Airport East precinct – WestConnex enabling works

Submissions Report

Prepared by Jacobs
ABN: 37 001 024 095

Figure 4-2 Land use and social infrastructure

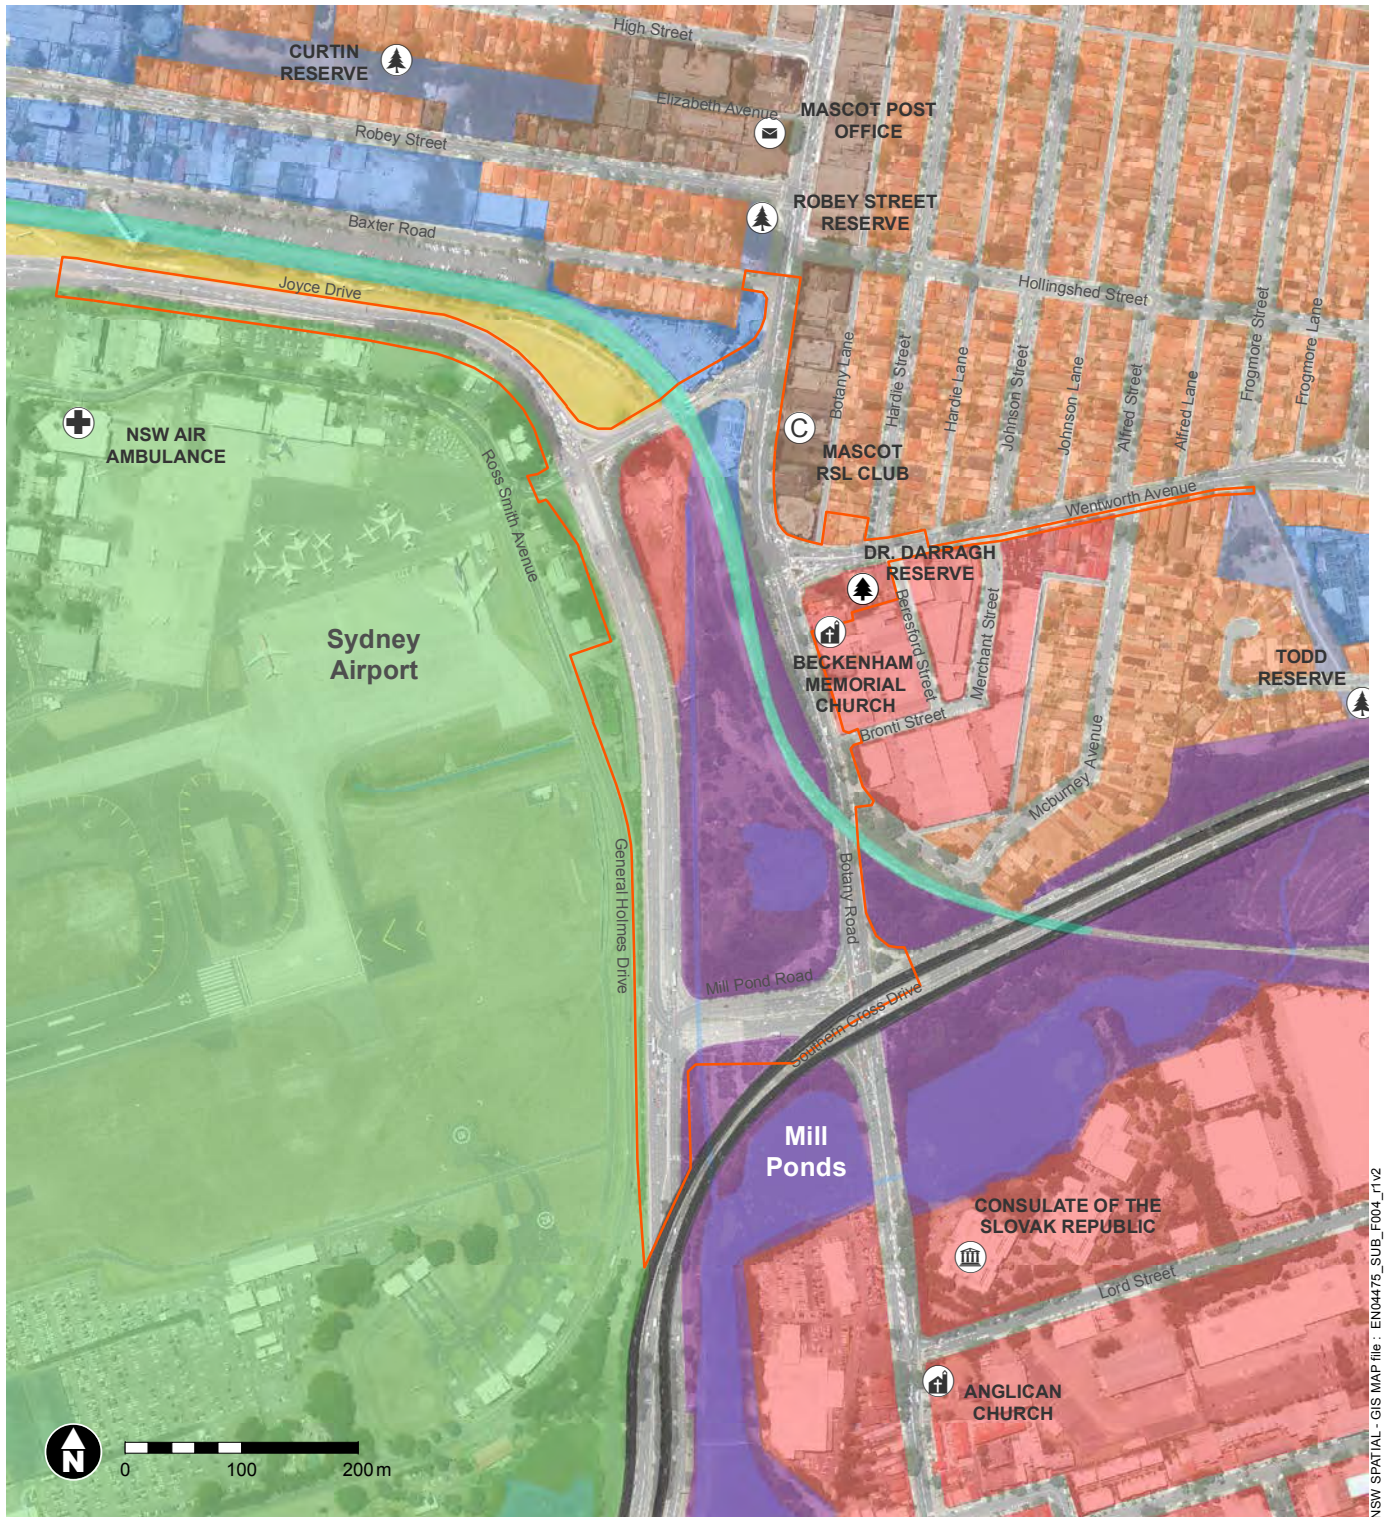
Stated that Figure 7-18 in the REF incorrectly identifies Ascot Lodge as 'unused land'.

The land use and social infrastructure figure has been updated and included as **Figure 4-2**.

Social infrastructure located within or near the proposal and land use types are shown in **Figure 4-2**.
